Staff Report

Report To: City Council
Report From: Sabine Robart, Intermediate Planner
Meeting Date: August 26, 2019
Report Code: CS-19-107
Subject: Recommendation Report Respecting Zoning By-law
Amendment No. 28 and Site Plan Approval ST2018-016
1200 16th Avenue East (API Hotel)

DRAWING TITLE
NORTH & SOUTH ELEVATIONS

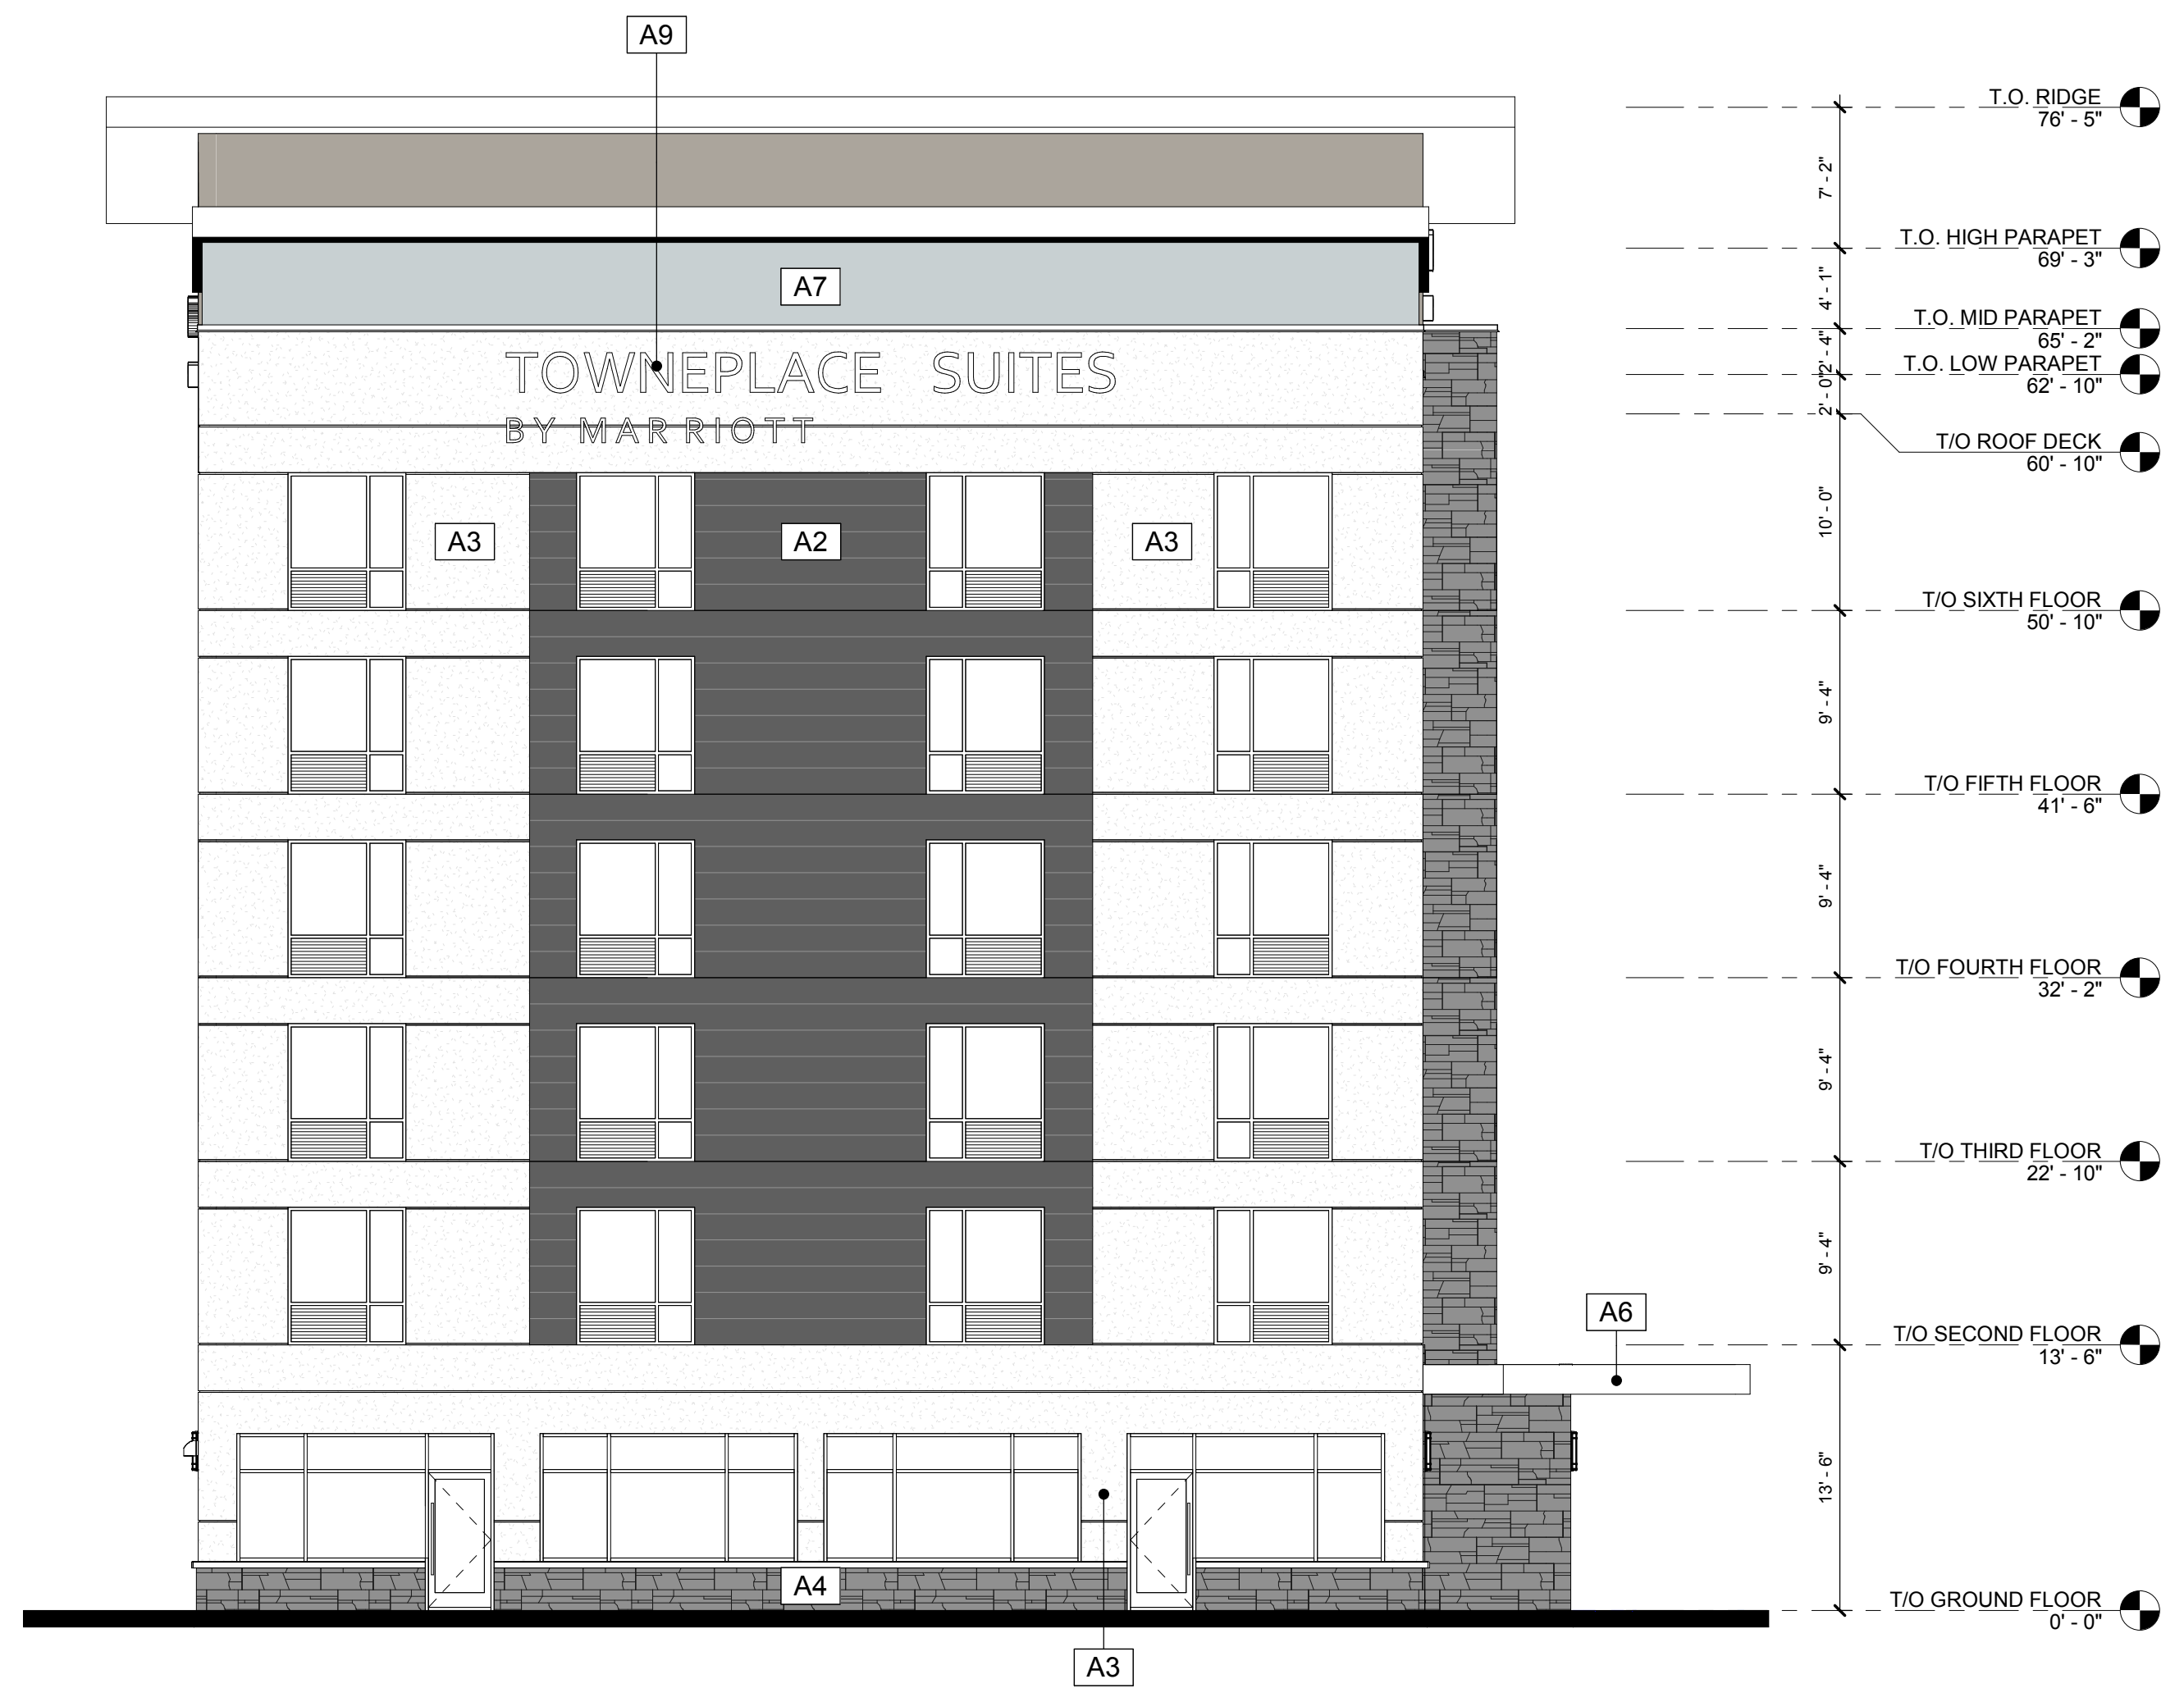
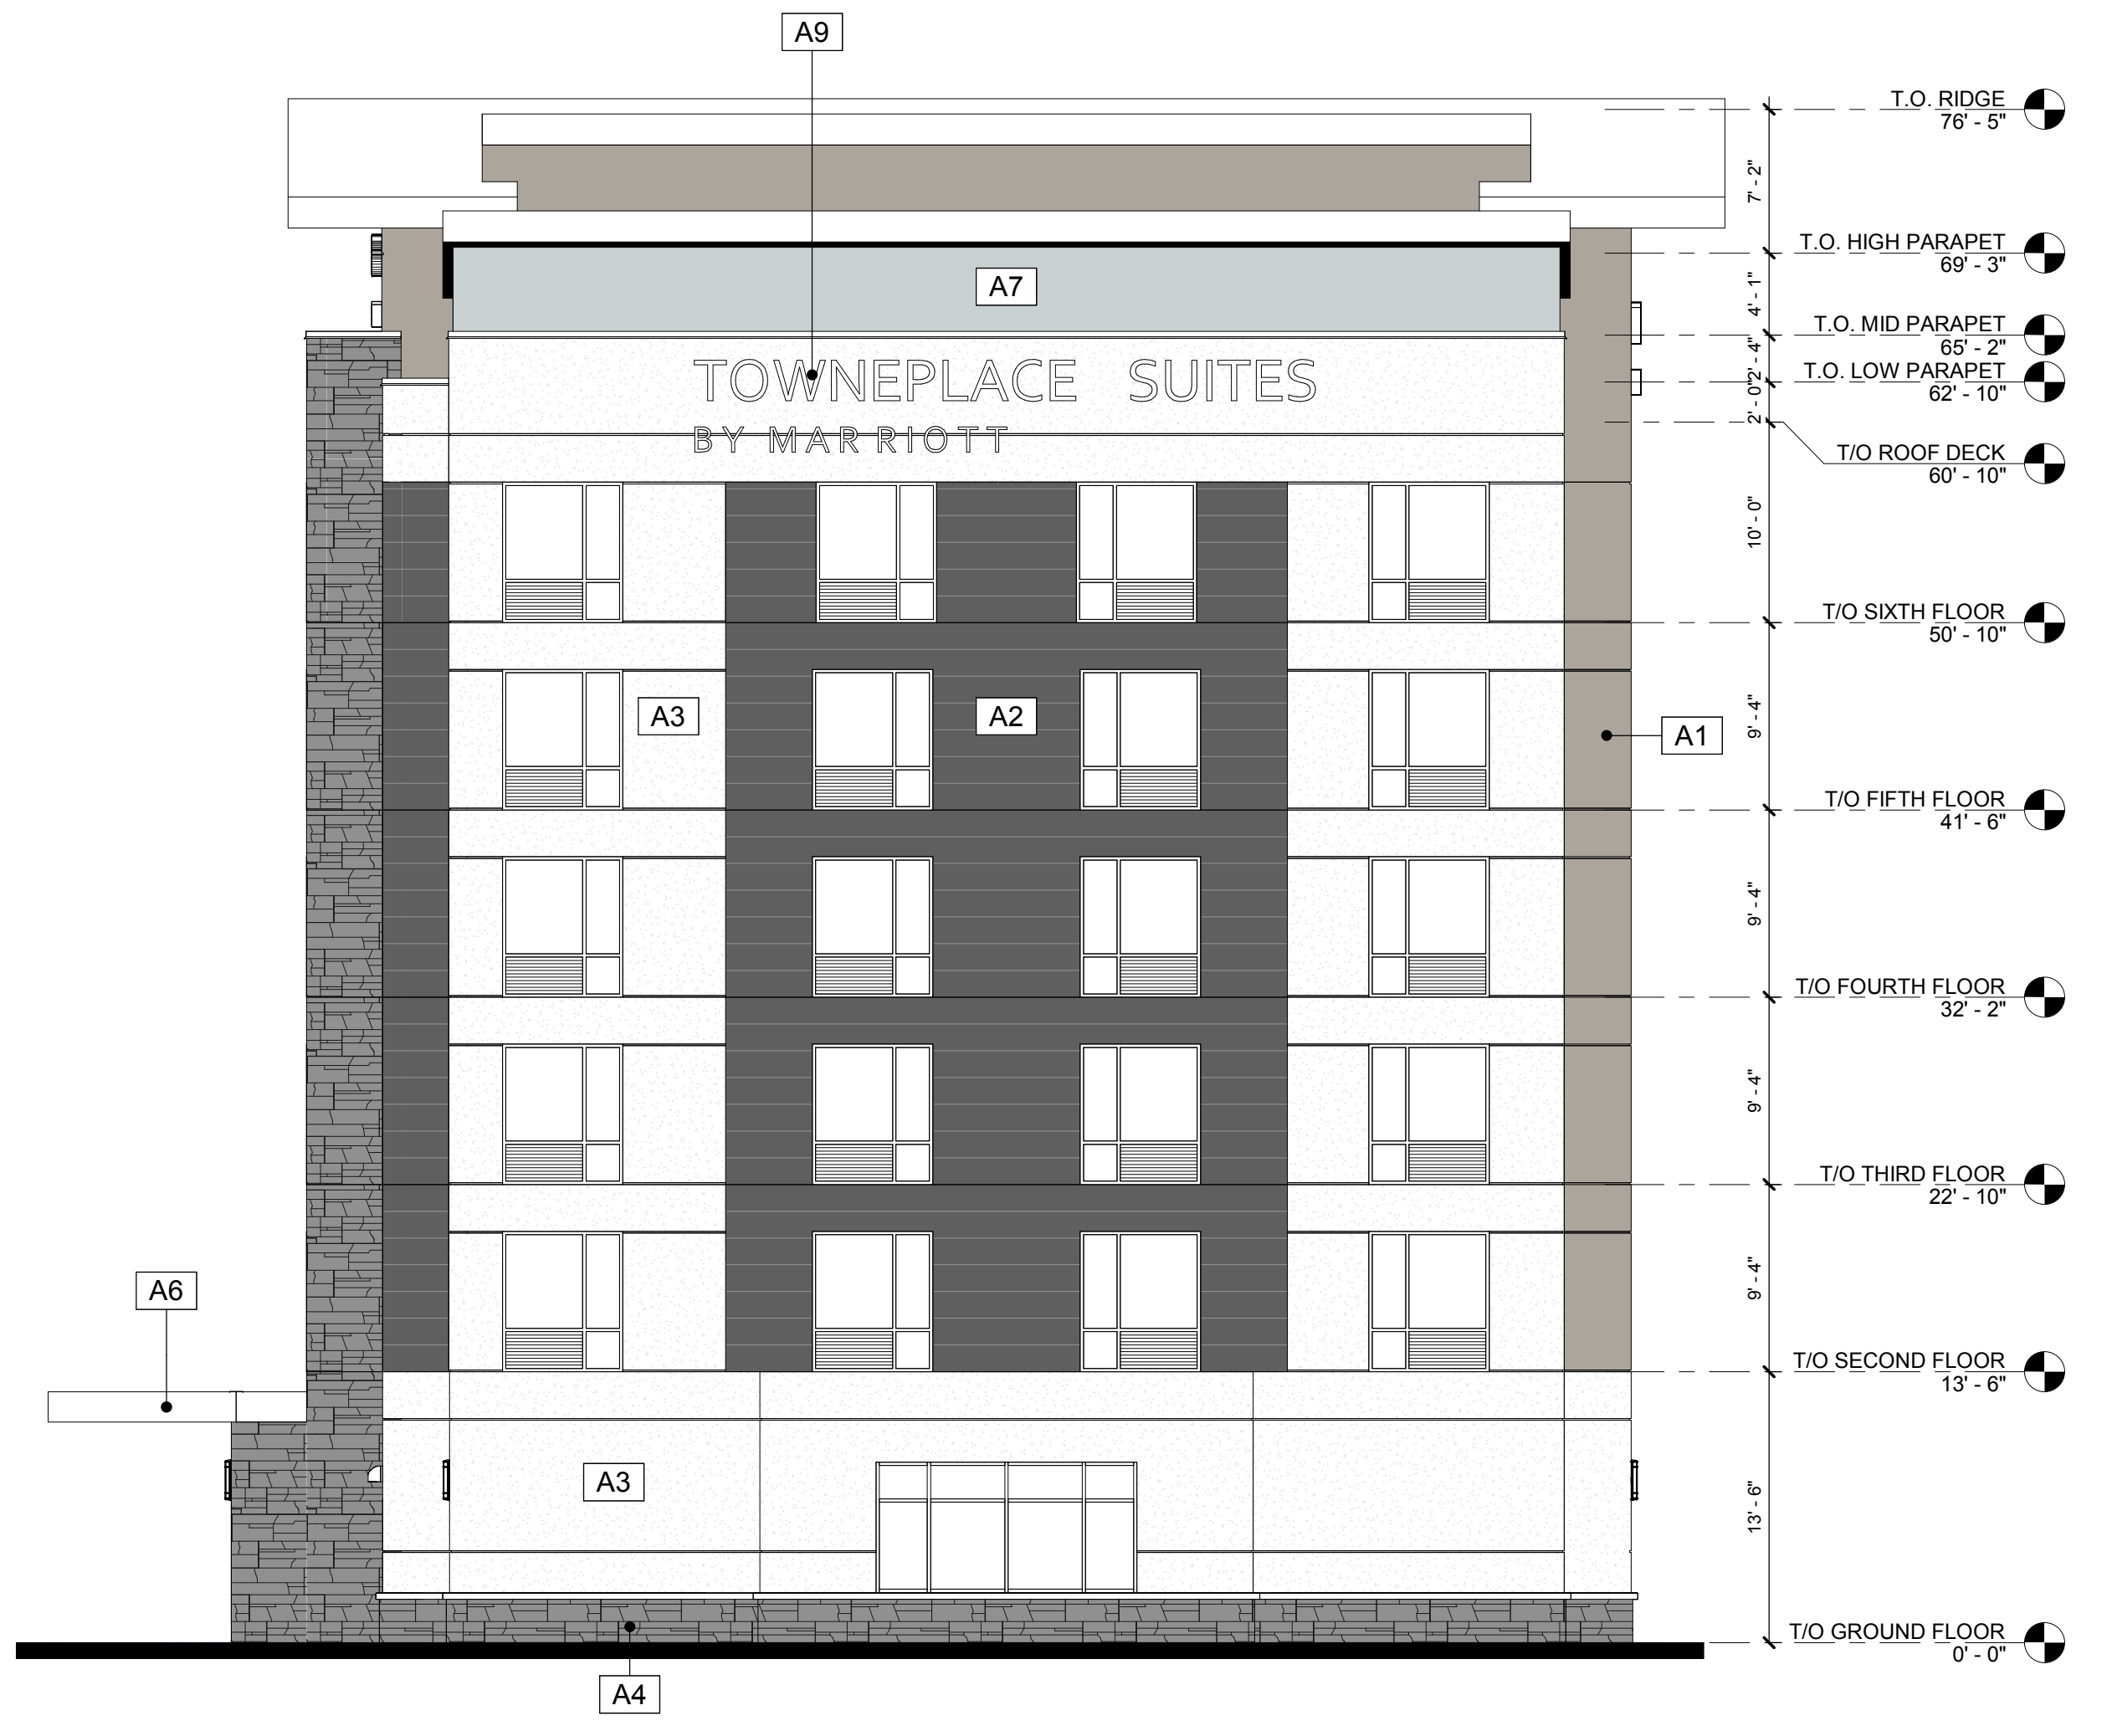
The functional height increase for the flat roof of the hotel is minimal, however, the hotel design includes a decorative parapet wall. At its tallest point the parapet is proposed to be 4.8 m in height (Schedule D – Proposed Elevations). The parapet proposed for the hotel roof will provide architectural interest to the building and will minimize the visual impact of any mechanical equipment on the roof of the building. From an urban design standpoint, this is positive. The Zoning By-law definition of ‘Building Height’ requires that the highest point on a flat roof, excluding mechanical equipment, be accounted for in the building height measurement. The height of the parapet accounts for the majority of the requested height increase. The design and height of the parapet varies along the roof line and the maximum parapet height does not occur across the full façade of the building thereby reducing the potential impact of the increased height. As noted above, the shadowing study indicates minor shadow impact on adjacent properties for a relative short time. The proposed hotel height increase from 18 m to a maximum of 23.3 m for the parapet wall is believed to meet the general intent and purpose of the Zoning By-law.
